STAFF REPORT

Planning Commission Meeting: May 13, 2024

Application:	<u>RZ24-0007</u>: Request for approval of a rezoning and preliminary site development plan for Primrose School of Olathe.
Location:	Southwest of W. 158 th Street and S. Hunter Street
Owner:	Timothy Anschutz, Spark Properties Group, LLC
Engineer/Applicant:	Luke Moore; Olsson
Staff Contact:	Andrea Fair, AICP; Planner II

GENERAL LAYOUT PLAN
PRELIMINARY DEVELOPMENT PLAN
PRIMROSE SCHOOL OF OLATHE
159TH STREET AND S. RIDGEVIEW ROAD

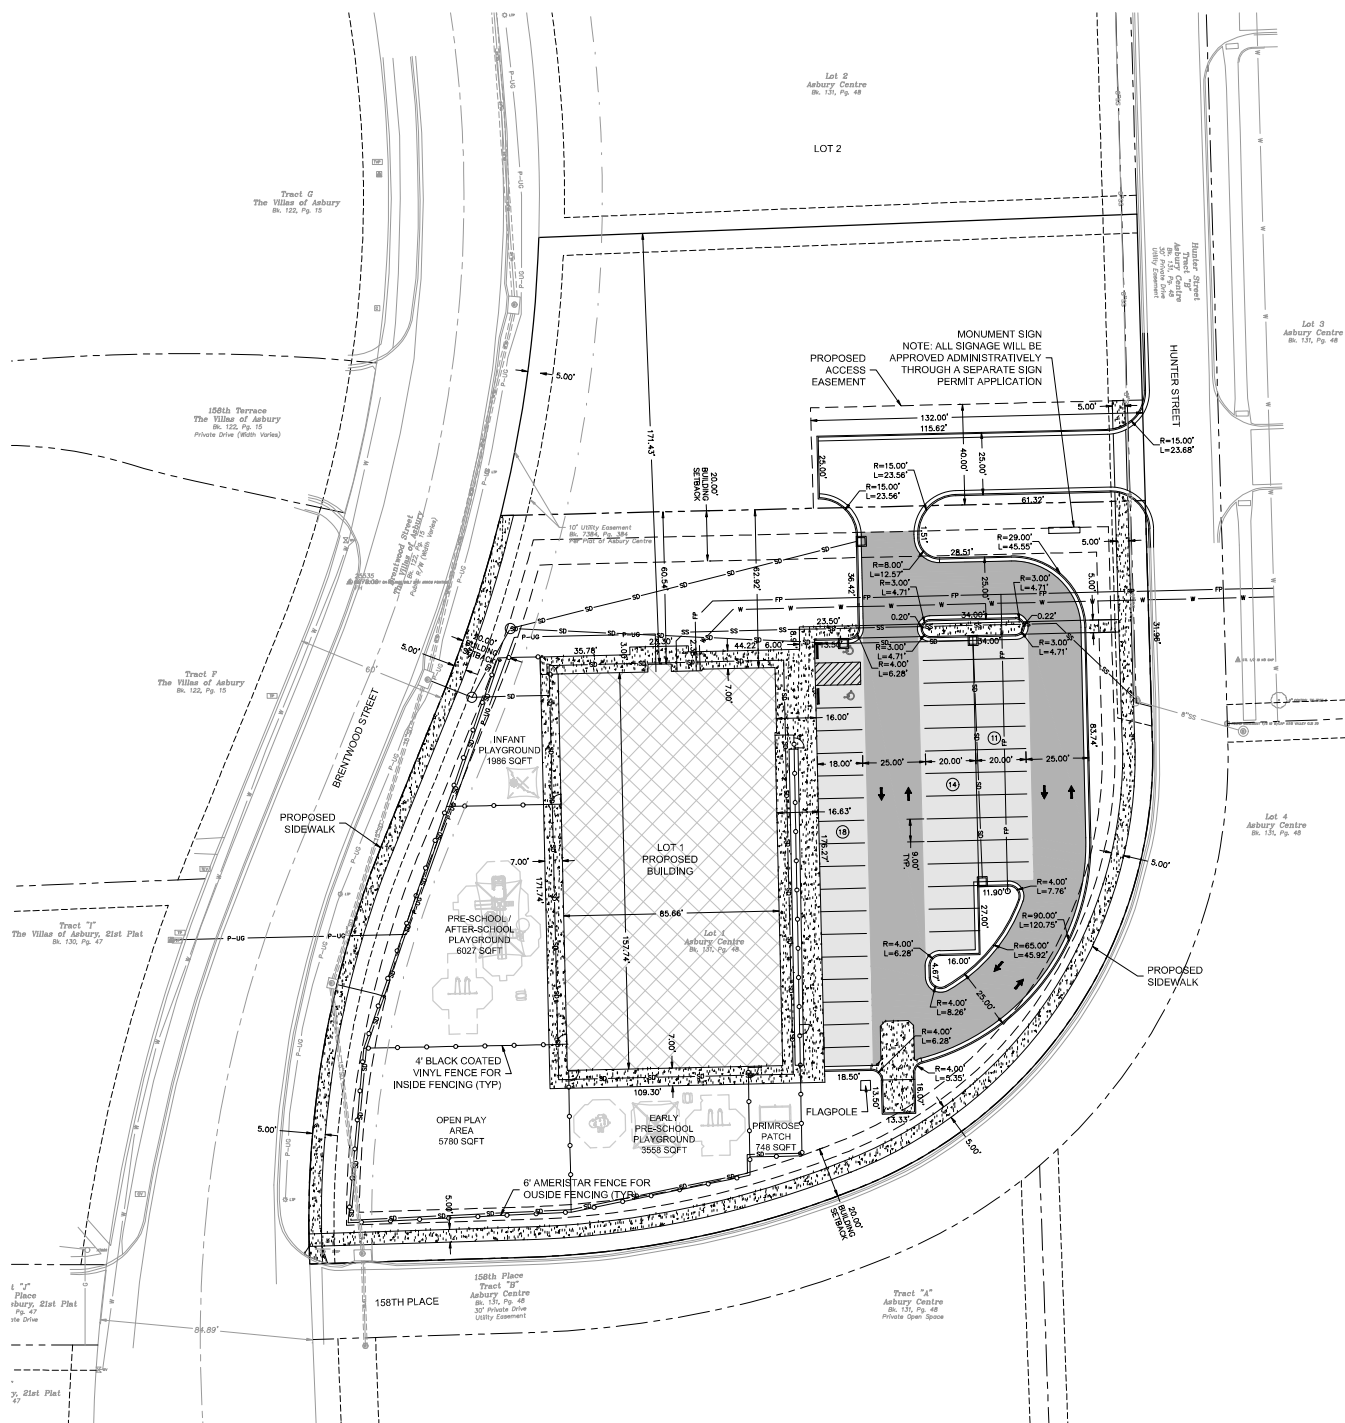
The C-1 District also requires that parking areas should not exceed 125% of the minimum required off-street parking requirements of the UDO, for a maximum of 21 stalls. The applicant is requesting a waiver to the maximum parking requirement, which is detailed in Waiver Request, Section 9.

- b. **Street Frontage Area** – Street frontage area for commercial and mixed-use buildings in Site Design Category 3 must be setback a maximum of fifteen (15) feet as measured from the property line. The day care building is setback 60 feet from S. Hunter Street and therefore does not comply with this requirement.

The applicant is requesting a waiver to street frontage requirement, which is detailed in Waiver Request, Section 9.

3. UDO 18.20.130.C.1, which requires that no more than 125% of the required parking for a use may be provided on site. The applicant is requesting to increase the parking from the required 17 spaces to 43 spaces.

- 2. A waiver is granted from UDO 18.15.115.C to reduce the street frontage setback and buildout requirement from 15 feet and 30% to a setback of 60 feet with the elimination of the façade width requirement, as shown on the preliminary site development dated April 22, 2024.

- 4. A waiver is granted from UDO 18.020.130.C.1 to exceed the 125% maximum parking requirement and permit a maximum of 43 parking stalls, as shown on the preliminary site development plan dated April 1, 2024.

MATERIAL BOARD AND COLORED ELEVATION
PRIMROSE SCHOOL
Prototype "The Erwin"
Olathe, KS 66062
04/22/24

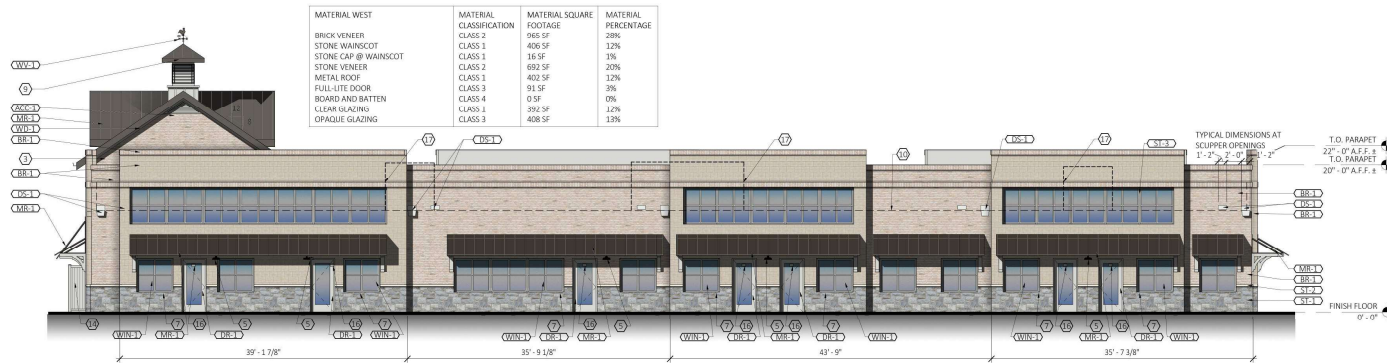
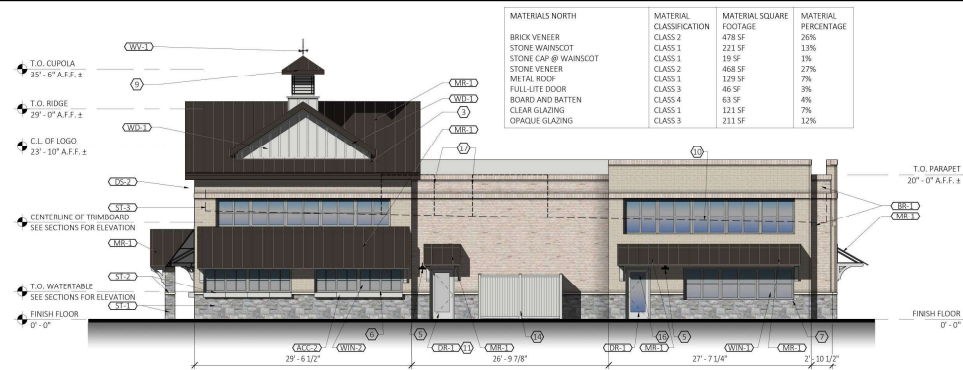
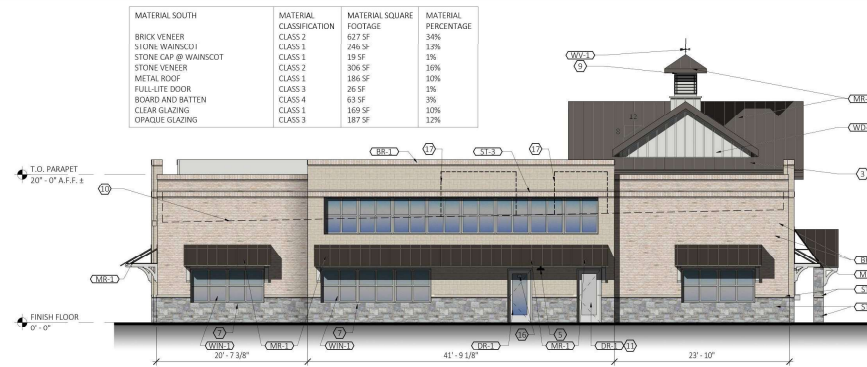
The building is required to have 25% clear glass on all primary façades. Clear glass windows are used on 7% of the north façade, 10% of the south façade, 11% of the east façade and 12% of the west façade. Opaque glass windows are also incorporated on 12% of the north façade, 12% of the south façade, 12% of the east façade and 13% of the west façade. The applicant is requesting a waiver to the minimum clear glass requirements. See Section 9 below for an analysis of this waiver request.

1. UDO 18.15.115, which requires street frontage area for commercial buildings be a maximum of 15 feet as measured from the property line and the façade width within the frontage area must be a minimum of 30% of the lot width. The applicant is requesting a setback of 60 feet from the front (east) property line.
2. UDO 18.15.020.G.8.b, which requires that clear glass comprise a minimum of 25% of any primary façade. The applicant is requesting to reduce the clear glass from 25% on all primary façades to 7% on the north façade, 10% on the south façade, 11% on the east façade and 12% on the west façade.

A waiver is being requested for the exterior glazing requirements identified in UDO 18.15.020. The requirement states that we are to have a minimum of 25% glass on at least two exterior facades. We have resubmitted architectural elevations where all four facades have either met the 25% glass requirement or the percentage is very close. This amount of glazing has increased significantly on all four facades from our initial design. The tower element on the north and east facades now has spandrel glazing as well.

The architect and developer requests a lower amount of glazing than required due to the needs and requirements for classrooms associated with the Primrose schools. Within each classroom, it is preferred to have a certain percentage of opaque wall space instead of windows or glass to assist with classroom needs. These needs can include wall space for instructional purposes, space to facilitate lessons led by the teachers and staff, or educational decoration to supplement the classroom teaching. The request for a lower amount of glass is also led by the need for the safety of students and staff. Privacy is a concern for students and staff and an increased number of windows could prohibit some of those desired safety measures. In the event of a lockdown situation, staff will need to be able to conceal and black out any windows or glass in a timely manner to promote their safety and the students' safety. These are a few of the reasons why the 25% required glazing was not originally presented and the continued reason for Primrose's request for a waiver.

- 3. A waiver is granted from UDO 18.15.020.G.8.b to decrease the minimum glass requirement from 25% on all primary façades to 7% on the north façade, 10% on the south façade, 11% on the east façade and 12% west façade as shown on the elevations dated April 22, 2023.
